Technical Service Bulletin: tsb100645

Released Date: 13-Nov-2007

Revised Fan Drive Idler Arm Assembly

08600775

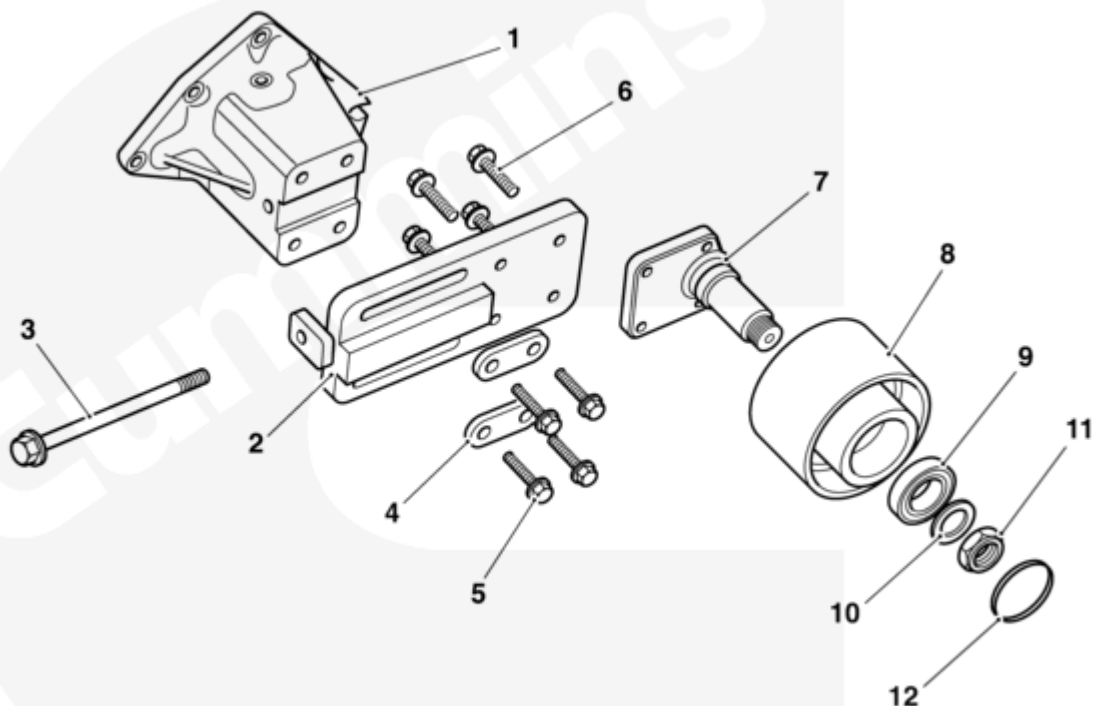
This purpose of This Technical Service Bulletin is to introduce a revised the fan drive idler arm assembly for the QSK60, WA1200 fan option FA6236. The revised design will improve fan hub reliability and durability.

The revised fan drive idler arm went into production in August 2007 at the Daventry Engine Plant. Engine serial number first was 33170187.
